Addendum No. 001

Subject: 2020 Classroom Modernizations

Location: John Welsh School

This Addendum, dated February 28, 2020, shall modify and become part of the Contract Documents for the work of this project. Any items not mentioned herein, or affected by, shall be performed strictly in accordance with the original documents.

1 ELECTRICAL THIRD FLOOR POWER PLAN
E2.3 1/8" = 1'-0"

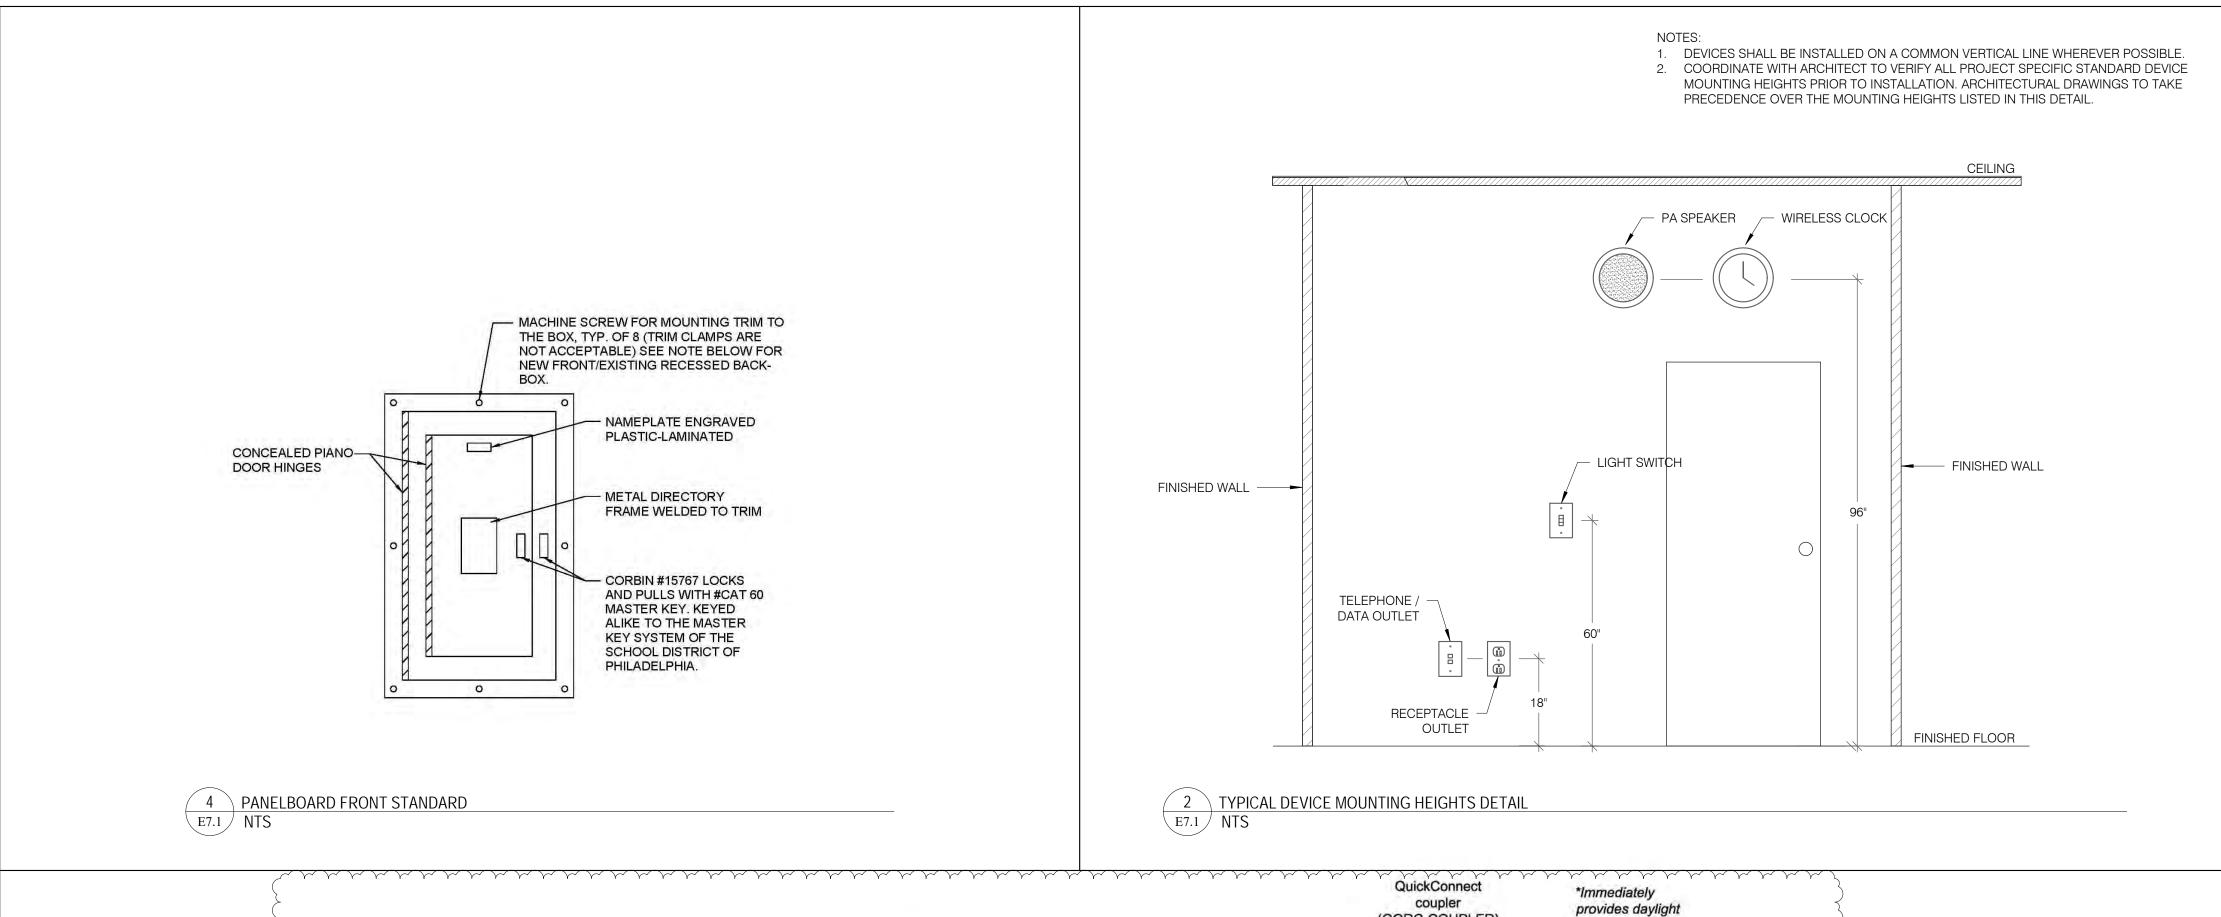
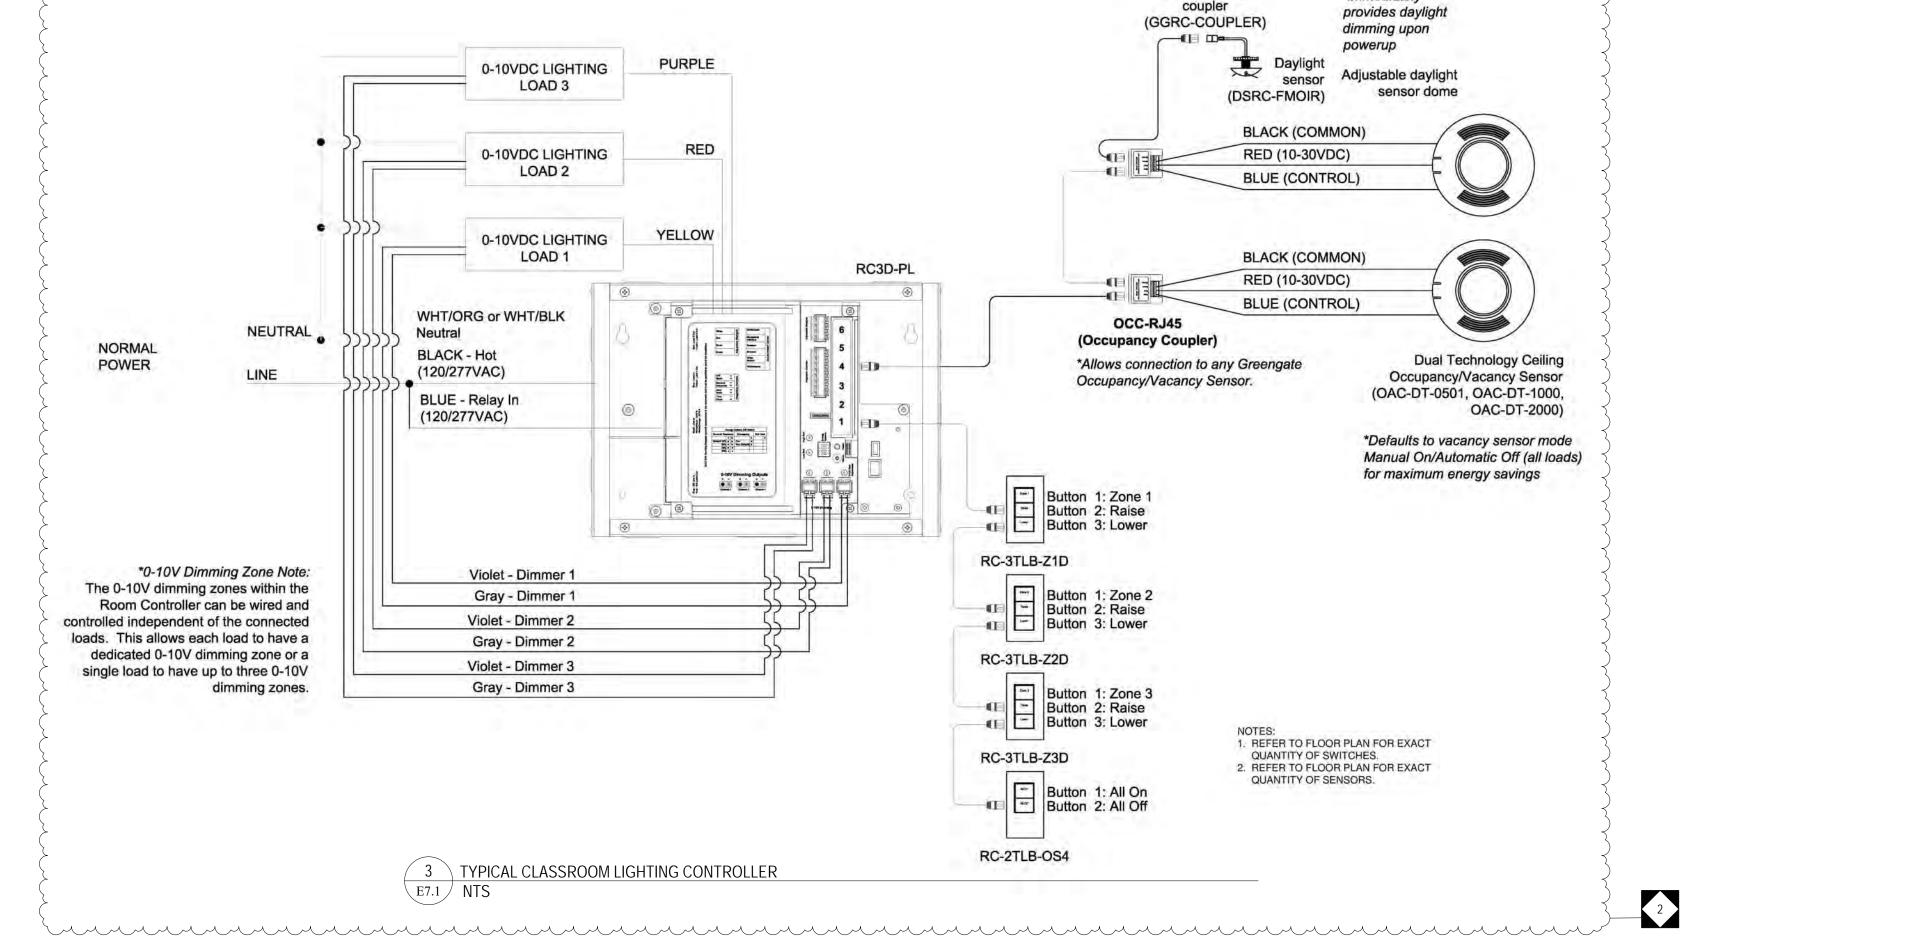
- ADD general sheet note #6 to read "ELECTRICAL CONTRACTOR TO RUN ALL NEW SURFACE MOUNTED CONDUITS AND RACEWAYS IN CORNERS OFF EACH CLASSROOM TO AVOID CONFLICT WITH DISPLAY BOARDS AND OTHER CLASSROOM FURNISHINGS."
- 2. REVISE data outlet locations and scope as indicated on the drawings.
